MECKLENBURG COUNTY
DEPARTMENT OF ENVIRONMENTAL HEALTH

APPLICATION FOR SOIL INVESTIGATION

SIR. NO. 19890
T.C. NO. PO 033-111-07
DATE: 7-26-83

SITE EVALUATION

**See Diagram on Back (includes: soil areas, property lines, roads, streams, gullies, wet areas, fill areas, wells, water bodies, slopes)

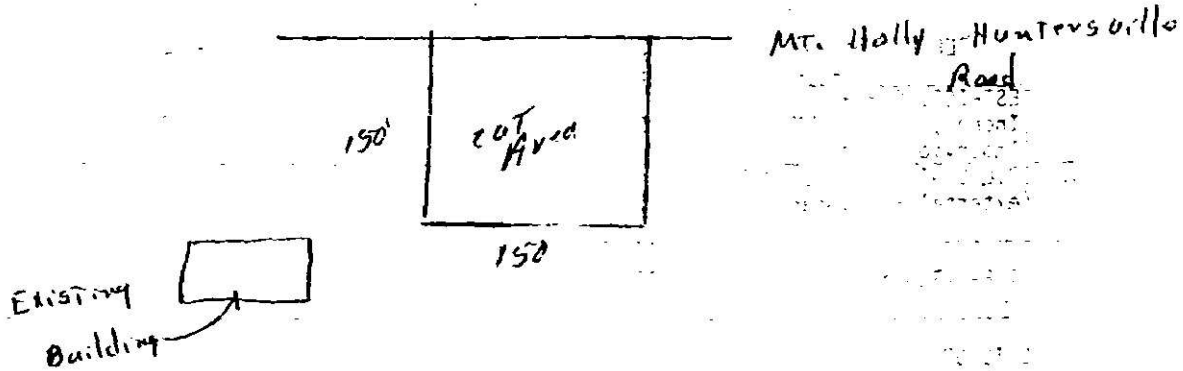
At your request, a field investigation was conducted on the property designated above and was classified unsuitable for the installation of a ground absorption sewage disposal system. A copy of the site evaluation report is enclosed for your information.

FACTORS	AREA 1	AREA 2	AREA 3	AREA 4
1. SLOPE (%)	S 2 6% PS U	S PS U	S PS U	S PS U
2. SOIL TEXTURE (12-36 inches) Sandy, Loamy, Clayey (Note 2-1 Clay)	S PS clay U	S PS U	S PS U	S PS U
3. SOIL STRUCTURE (12-36 inches)	S PS Blocky U	S PS U	S PS U	S PS U
4. SOIL DEPTH (inches)	S 12-36" PS U	S PS U	S PS U	S PS U
5. RESTRICTIVE HORIZONS (Inches) (Impervious strata, Rock)	S Saprolite PS 12-36" U Rock Stones	S PS U	S PS U	S PS U
6. SOIL DRAINAGE/GROUNDWATER (external and internal)	S PS 7-36" Perched water U	S PS U	S PS U	S PS U
7. OTHER (Specify)	S PS U	S PS U	S PS U	S PS U
8. SOIL GROUP	III A			
9. SITE CLASSIFICATION	Unsuitable			
10. SOIL SERIES	Cat Area
